UNITED STATES PATENT AND TRADEMARK OFFICE

Office Action Summary	Application No. 10/522,502	Applicant(s) ERTLE ET AL.
	Examiner ROBERT HUBER	Art Unit 2892

DETAILED ACTION

FIG. 2

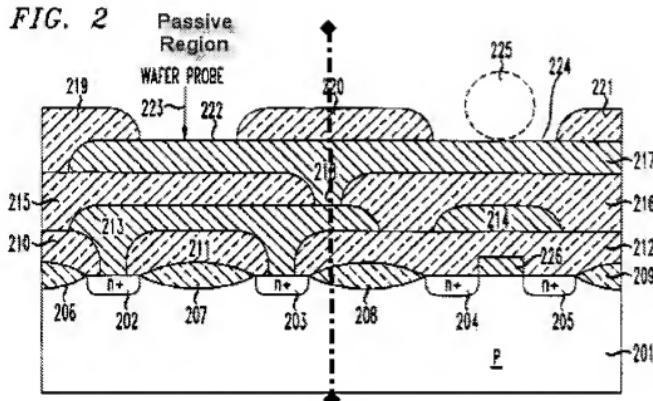
b. Regarding claim 38, **Strauss discloses a semiconductor wafer** (e.g. figures 2 and 3) **comprising:**

a semiconductor chip (chip as seen in figures 2 and 3) **having a passive first region** (first region under wafer probe pad 222, as clarified in the figure below) **and an active second region** (active second region under contact pad 224, as clarified in the figure below), **the semiconductor chip having an arrangement of contact areas** (contact areas 222) **and test areas** (test areas 224) **which are arranged in a common plane** (e.g. top surface of the areas are in a common plane) **and are electrically conductively connected to one another via a conduction web that lies in the common plane** (e.g. conducting web of layer 217 under layer 220, which has a top surfaces that is in the common plane as the test areas and contact areas 222 and 224), **wherein the contact areas are not sealed** (as seen in figure 2, the contact area 222 may be considered to be not sealed since it's top surface is exposed);

the contact areas being arranged in the passive first region of the top side of the semiconductor chip (contact areas 222 are in the passive region), **the passive first region having no active components of an integrated circuit** (as seen in figure 2, there are no active devices in this region); **and**

the test areas being arranged in the active second region of the top side of the semiconductor chip (test areas 224 are in the active region), **the active second region having active components of an integrated circuit**

(e.g. as seen in figure 2, the active second region has a transistor comprising source 204, drain 205, and gate 226); **and**

an insulating layer (insulating layer 216) **having through contacts** (through contact 218) **arranged in the region of the conduction web and extending from the conduction web to a lower plane** (as seen in figure 2), the through contacts being connected to interconnects that are connected to the components of the integrated circuit (e.g. vias connected to interconnects 213 and the components of the integrated circuit as described in col. 2, lines 45 - 48);

wherein the contact areas and the test areas are free from the through contacts (as seen in figure 2, the contact and test areas are free from the through contacts);

the semiconductor chip being defined by a boundary around the respective semiconductor chip (e.g. outer boundary as seen in figure 3), the contact areas and the test areas are completely situated within the boundary of the respective semiconductor chip (as seen in figure 3, and disclosed in col. 3, line 15 and lines 23 - 26, the test areas and contact areas are within the boundary of the semiconductor chip).

Strauss is also silent with respect to disclosing the test areas are sealed. However, Strauss discloses the test areas are partially sealed (e.g. the test areas may be considered to be partially sealed since the bottom is sealed by layer 216, and the tops are partially sealed by layer 220/221).
